PROCESS SYSTEMS INTERNATIONAL
DOCUMENT REVIEW CHECKLIST

Edwards ENGINEERING CORP.
PHYSICAL DRIVING UNIT

PHYSICAL DRAWING FOR THE MODEL NO. PACKAGED AIR-COOLED CHILLER UNIT

S/N: 966505 & 966506 LIGO-DGX1061-CO-V

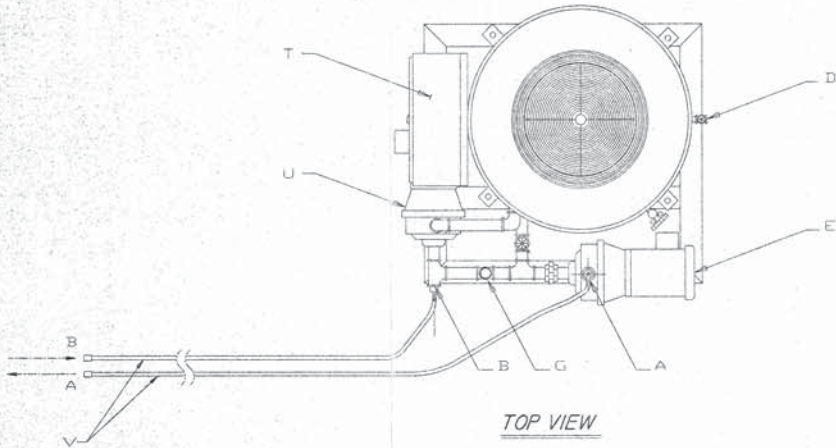
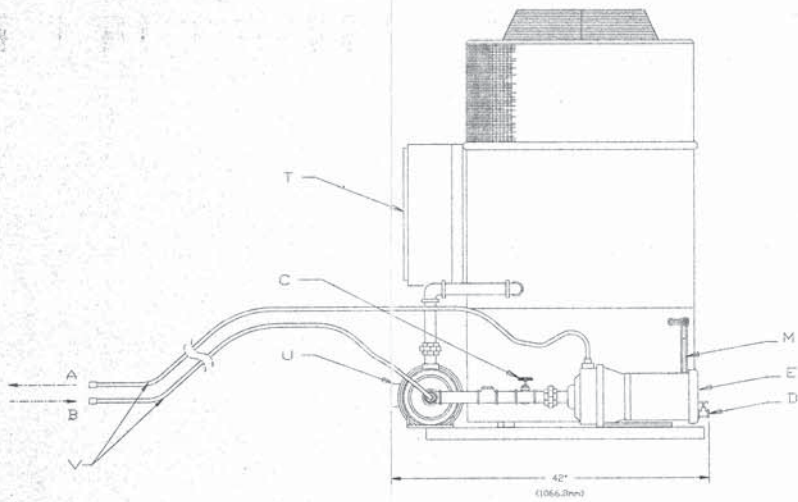
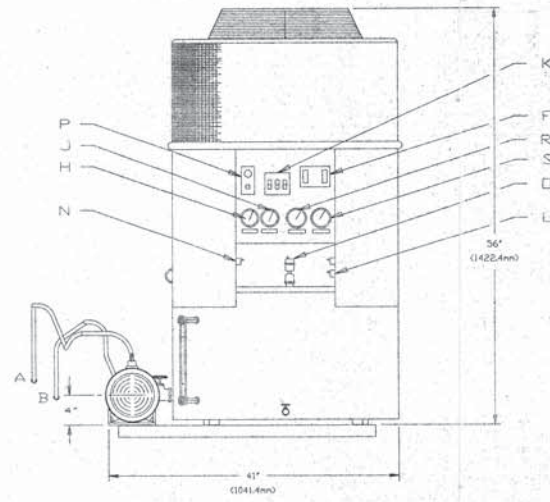
CUSTOMER CONNECTORS ARE CORRECT SIZE. HOSE SIZE TO BE MIN. 3/4" OR 1"
